15TH FEBRUARY 1892, No. 473 W., PUBLIC WORKS.

GOVERNMENT OF MADRAS.
PUBLIC WORKS DEPARTMENT.

School with Out-houses at
Koduvayur, Malabar District
Estimate of Rs. 7,210 for constructing a
—, sanctioned with remarks.

Constructing a School house with
out houses at Koduvayur
Malabar Dist.
Amount of Estimate Rs 7,190

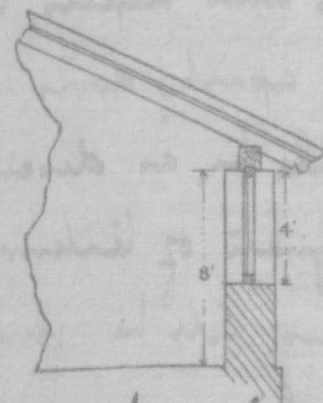
The lintels as at present
designed would not
support the ~~rafters~~
the superstructure
weight of masonry.

The roof is a light
one - Mission tiles
and no ceiling -
and the arrangement
now proposed would
answer but the
brassmum lighter large
abutting -

The large windows at rear
of copying room 13'9" wide are
provided with wooden lintels
12" wide and 3" thick. It would
perhaps be better to omit the
lintels with the masonry and
wall plates (5"x4") above and
substitute a brassmum say
8'6" x 12" to rest on the square
pillars, raising the sill of the
windows a little higher so
as to notch the window frames
to the brassmum, as per sketch.

This would
prevent the
glare being in
level with the
eyes of the
pupils, while copying.
The window sills may
also be supported on stone
columns, as proposed for the
Officers' Mess at Muthupuram
instead of their ends being
in-
